Council Reference: A006904370  
Attention: Kayal Chandrasekar

**RE: Response to Further Advice – Minor Change to Material Change of Use  
for a Multiple Dwelling at 3 - 9 Byron Street, Bulimba**

We write on behalf of our client, 3 Byron St Pty Ltd, in response to Council's 27 April 2026 Further Advice regarding the pending Minor Change at 3 - 9 Byron Street, Bulimba (A006904370).

**Figure 1: Proposed Ground Floor Cabinet Relocation Options**

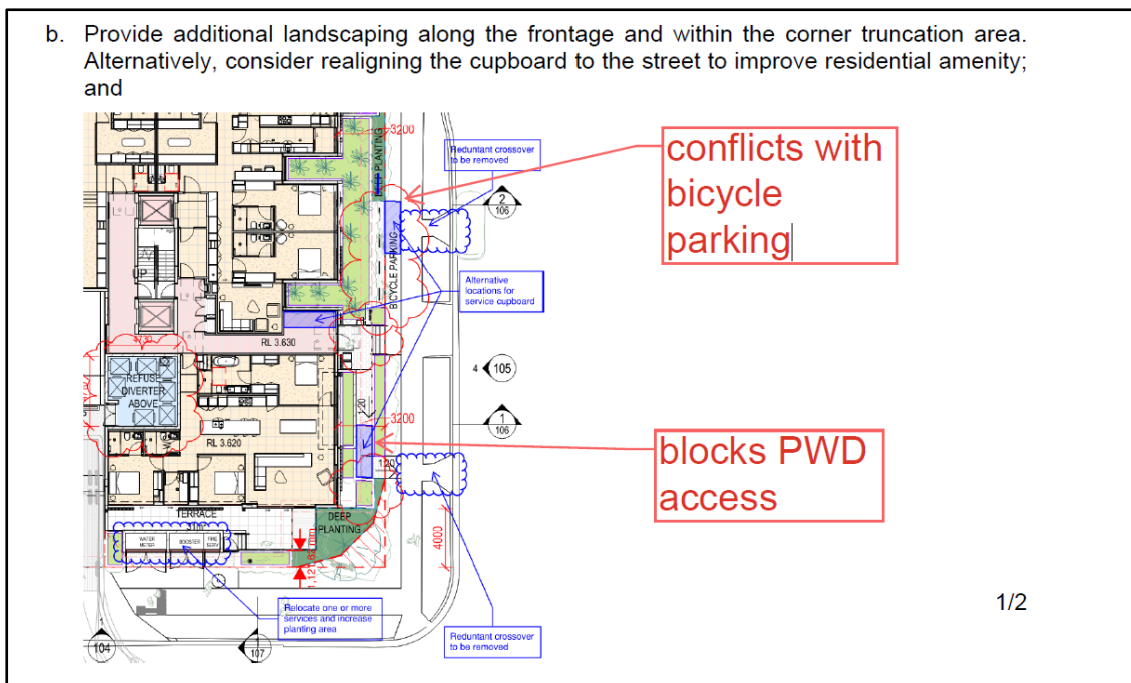
*1. The proposal allocates a substantial portion of the Byron Street frontage to services, including a pad-mounted transformer and relocated infrastructure. This outcome significantly undermines the achievement of a cohesive streetscape and built form character by limiting opportunities for casual surveillance and street activation, thereby failing to contribute to an appropriate balance between landscaping and built form. The proposal does not comply with PO3, PO4, PO5, PO6, PO8 and PO28 of the Multiple Dwelling Code. Submit amended design to relocate the water meters, booster, and fire services cupboard parallel as recommended below:*

*a. Relocate either Water meter or Booster/ Fire service cupboard to the Apollo Road frontage as shown in markups below;*

The applicant has undertaken a review of the service relocation options proposed by Council. Two options proposed include relocating services within the pedestrian access ramp or adjacent to the visitor bicycle parking on Apollo Road.

The ramp is approved for PWD access and is the only space available on either frontage to provide a wheelchair accessible ramp in accordance with Australian Standards. Therefore, the service cupboards cannot be relocated to this area (Figure 1).

Further to this, the area proposed on the northern portion of the Apollo Road frontage would result in the visitor bicycle spaces being obstructed (Figure 1). Relocating the visitor bicycle spaces further within the site would also result in a loss of landscaping and/or deep planting.

Figure 2: Amended Ground Floor Plan (Source: MODE)

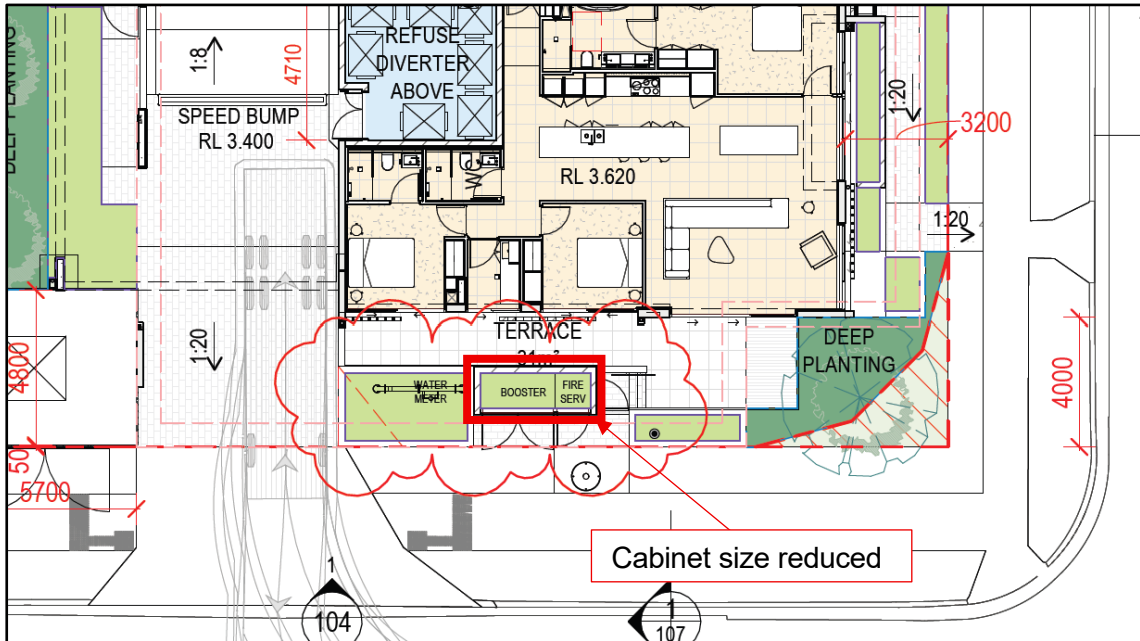
*b. Provide additional landscaping along the frontage and within the corner truncation area. Alternatively, consider realigning the cupboard to the street to improve residential amenity; and*

*c. Reduce the height of the cupboard associated with the water meters to the minimum height required and incorporate a planter of max 500mm depth atop the element to provide variation in height and appearance and soften the built form.*

Notwithstanding, several design amendments have been made to the servicing cabinets to improve the cohesive streetscape and built form character presenting to Byron Street. Specifically, the following amendments are proposed:

- The individual water meters will continue to be located internal to the site, away from the frontage.
- The water connection cabinet has been removed. The water connection will now be open to the sky and will be obscured from view by landscaping. This has significantly reduced the bulk of the solid masonry cabinets on Byron Street compared to the previous plan set and approved plans (See Figures 2, 3 and 4 & 5). This also opens up additional surveillance of Byron Street from the ground floor terrace.
- A shallow planter has been provided on top of the remaining cabinets to further reduce to perceived bulk when viewed from Byron Street.

Figure 6: Amended Ground Level Planter Plan (Source: CUSP)

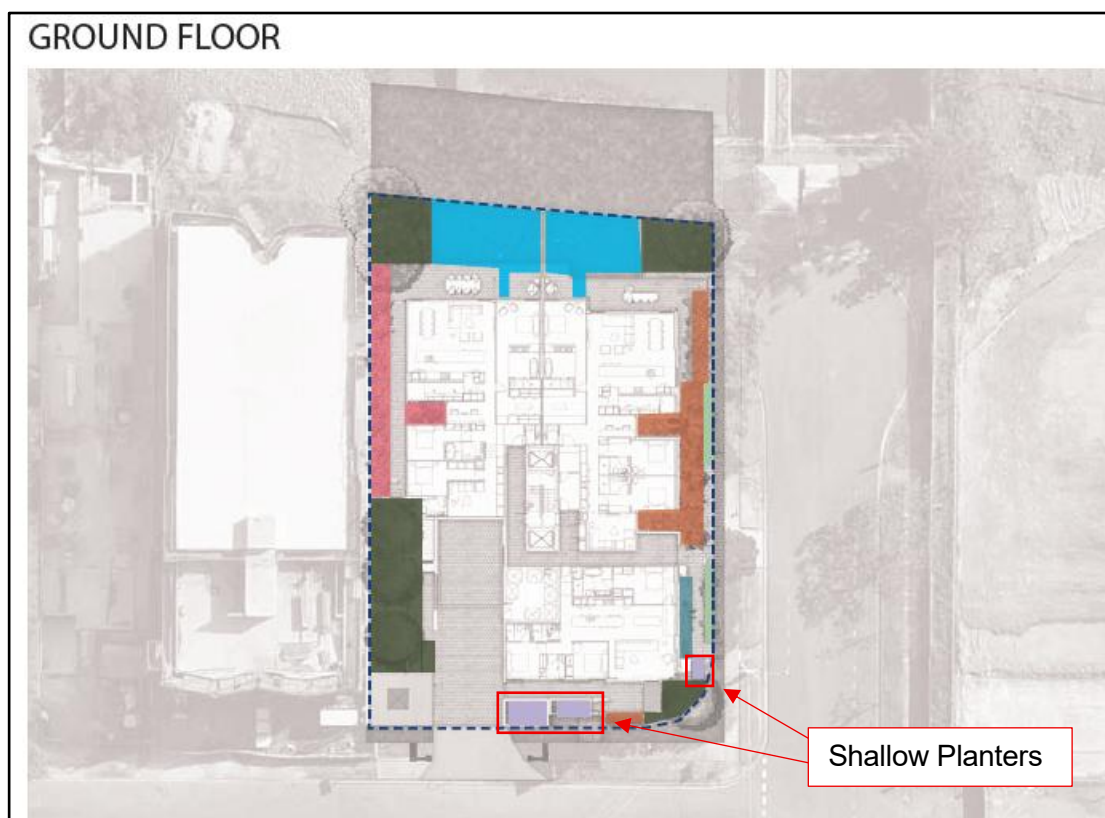
It is noted that Conditions 33(a) and 34(b) of the approval require minimum internal depths and widths for the proposed planters ranging from 600mm to 1200mm. The shallow planters added at ground level have a depth less than 600mm to minimise bulk at the street (Figure 6). As such, it is requested that Condition 33(a) and 34(b) are amended

- *for planter boxes:*
  - *adequate width, depth and suitability of soil for the planting. Minimum internal depths of planters unless otherwise endorsed by Development Services must be trees 1200mm; large shrubs and palms; 800mm; small shrubs and groundcovers; 600mm. **The minimum depths described above do not apply to the proposed Ground Level Shallow Planters depicted in Section 7.0 of the approved Landscape Concept Report (Issue J, dated 20.05.26);***

- Shade and/or round canopy trees planted at suitable spacings along front boundaries in planting areas shown on the approved drawings.
  - Minimum internal depths and widths sufficient to support healthy plant growth, with the following dimensions or other dimensions if achieving the same soil volume; trees - 1200mm width x depth, large shrubs and palms - 800mm width x depth, small shrubs and groundcovers - 600mm width x depth. *The minimum depths described above do not apply to the proposed Ground Level Shallow Planters depicted in Section 7.0 of the approved Landscape Concept Report (Issue J, dated 20.05.26).*

Figure 7: Amended Level 4 Plan (Source: MODE)

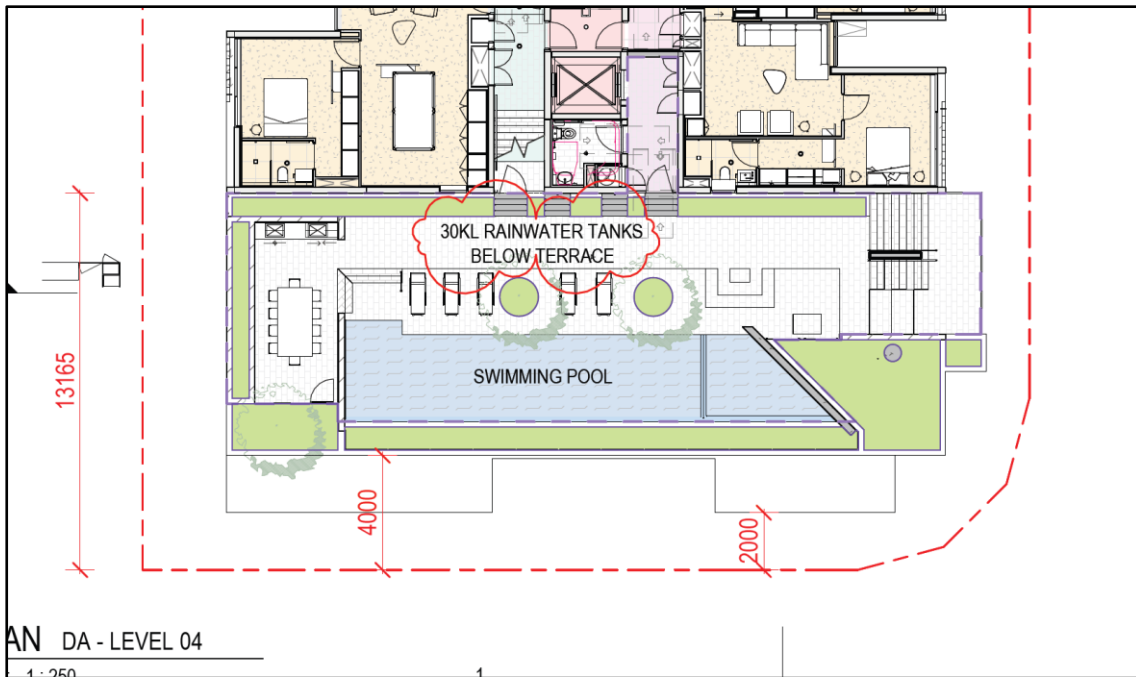
2. The proposed Landscape concept plans show 15KL rainwater tanks at Level 4 in place of 30KL tanks previously approved. The 30KL rainwater tank was less than the desirable capacity and any reduction is not able to be supported. The preliminary irrigation estimate is not prepared by a suitably qualified professional and does not concur with the Irrigation Water Usage, Catchment & Irrigation Strategy, prepared by Irrigation Design Australia and received on 26 May 2025, as part of the original approval (Council ref: A006702114). Provide amended plans showing 30KL rainwater tank capacity consistent with the approved plans.

Following ongoing discussions with Council, the architectural plans have been amended to include 30KL rainwater tanks.
